## ON-SITE SEWAGE DISPOSAL SYSTEM HOWARD COUNTY HEALTH DEPARTMENT BUREAU OF ENVIRONMENTAL HEALTH

**03-325695**

SUBDIVISION: Quarterfield III LOT NUMBER: 10

ADDRESS: 11655 Whitetail Lane PROPERTY OWNER: Williamsburg Group

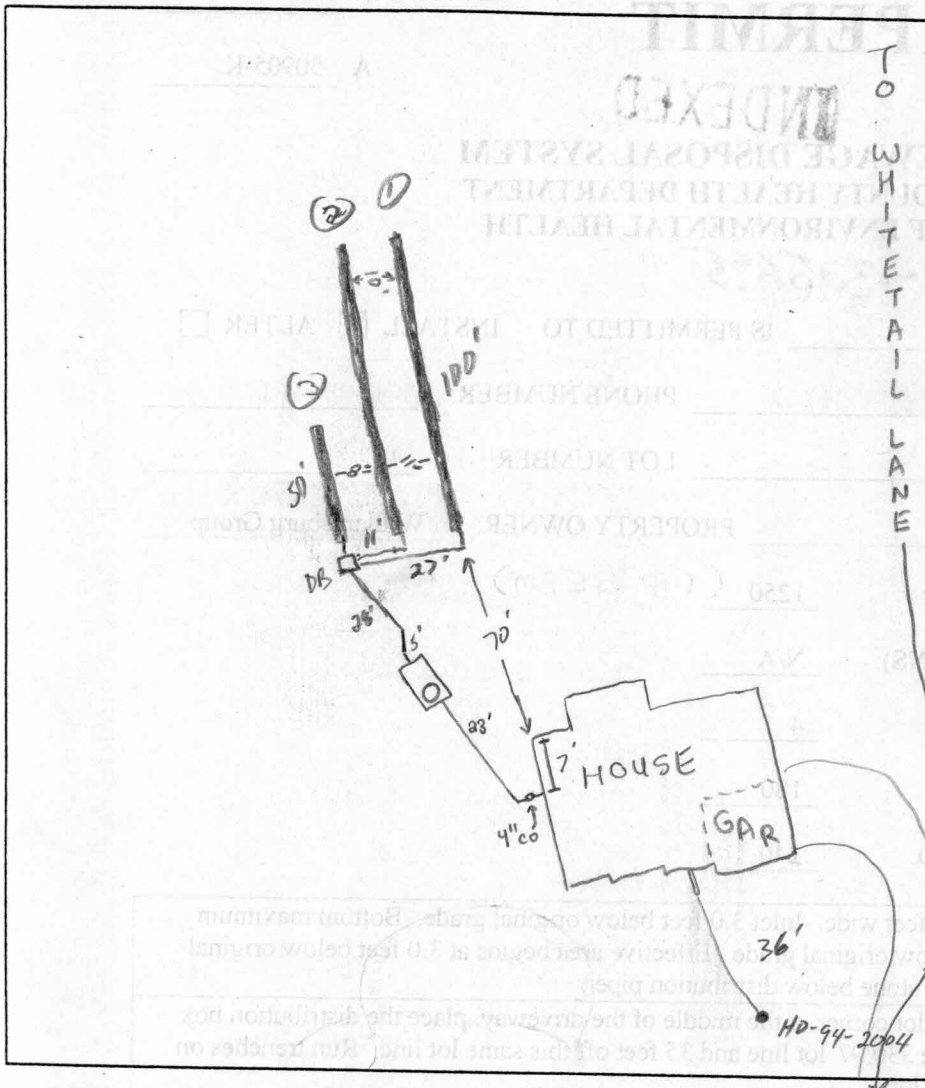
PRE-CONSTRUCTION INSPECTION: 9/27/01 - INSTALL PER PLAN, SDA STAKED, 2-100' & 40-50'

INSPECTION COMMENTS: 9/26/01 Line (1) & (2) covered, line (3) piped, stoned, puffed  
OK to cover. Line from tank drops 4' 11' between trenches  
@ lines 1 & 2. 8' between 2 & 3. Said they had to do this was because  
of contour. 1 & 2 are 100', 3 is 50'. Cinder block is DB for baffle
